Staff Report: Henderson Bridge conceptual review – Wayland – Ward 1 (For Discussion)

Presented at April 17, 2019 BPAC meeting

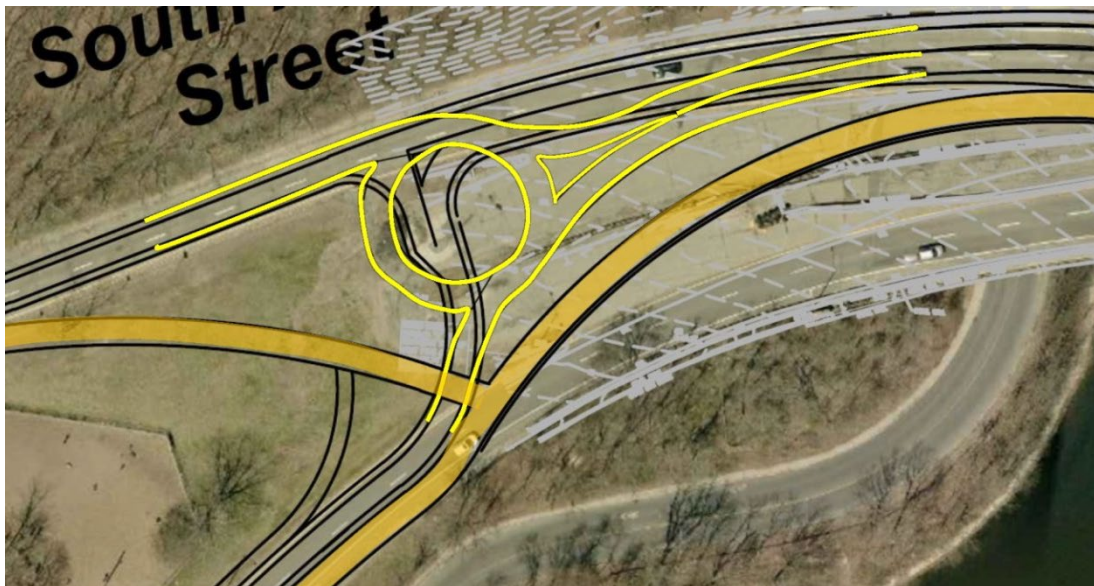
On the Providence side, the concept includes an uncontrolled (no signal or stop sign) T intersection near the foot of the bridge at the intersection of the bridge and South Angell Street. An alternative concept (below) includes a small single-lane roundabout, which could potentially do more to slow down traffic coming off the bridge toward South Angell Street than the uncontrolled T intersection currently proposed.

- The roundabout alternative or alternative options for slowing down westbound vehicular traffic coming off the bridge should be explored. If the T intersection concept is implemented, it should be modified to include traffic control or other traffic calming tools.

- Include traffic calming measures at the intersection of Waterman St with the bridge access road, such as aligning the intersection as close to a 90 degree angle as feasible, traffic controls such as stop signs or signals, bump-outs to narrow perceived width, and raised crossings.

- The HAWK signalized shared use path crossing across the connector road should be a raised crossing or should have advanced speed lumps installed to slow vehicular speed and further improve vulnerable road user safety.

- Along the connector road between Waterman and the bridge, a horizontal or vertical buffer should be included between the shared use path and the roadway to improve vulnerable road user safety.
